Hilfield Solar Farm and Battery Storage

Glint & Glare Assessment - Appendices

on behalf of Elstree Green Limited

Prepared by Pager Power Limited | December 2020 | Document Reference: R012

Impact significance definition

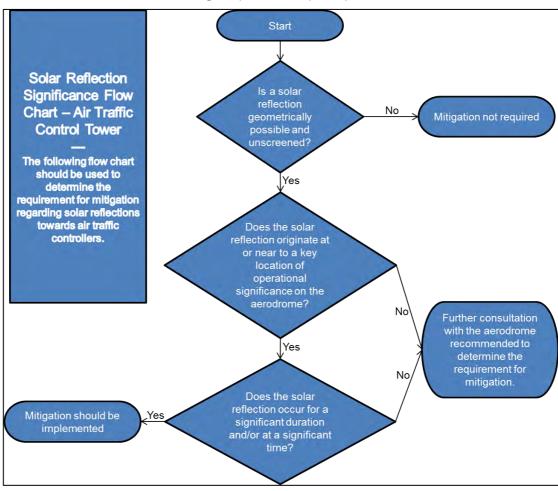
We would consider the impact significant and either moderate or major impact due to the possibility of after image to the pilots and the findings of this report be discussed with Elstree Aerodrome as to whether mitigation is required.

Approach 08

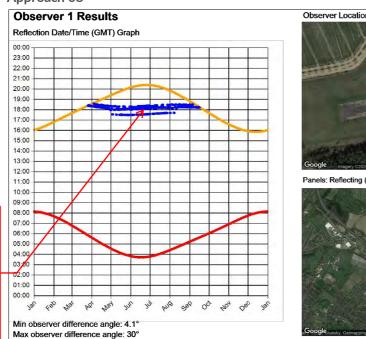
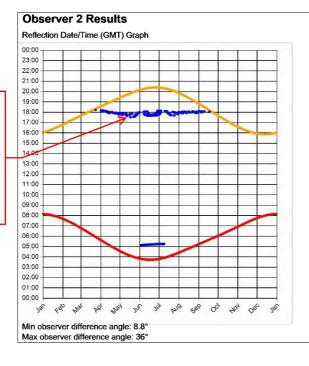
reflections seem almost constant between April and September at17.30-19:00

reflections seem almost constant between April and September at17.00-18:00

APPENDIX I - LEEP PLAN

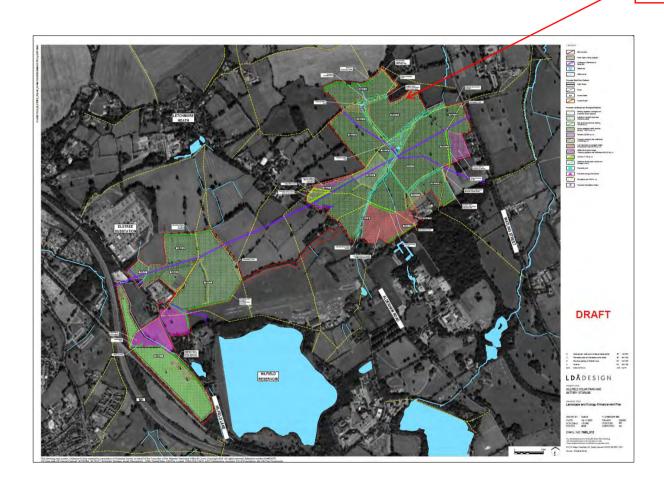
This is unreadable.
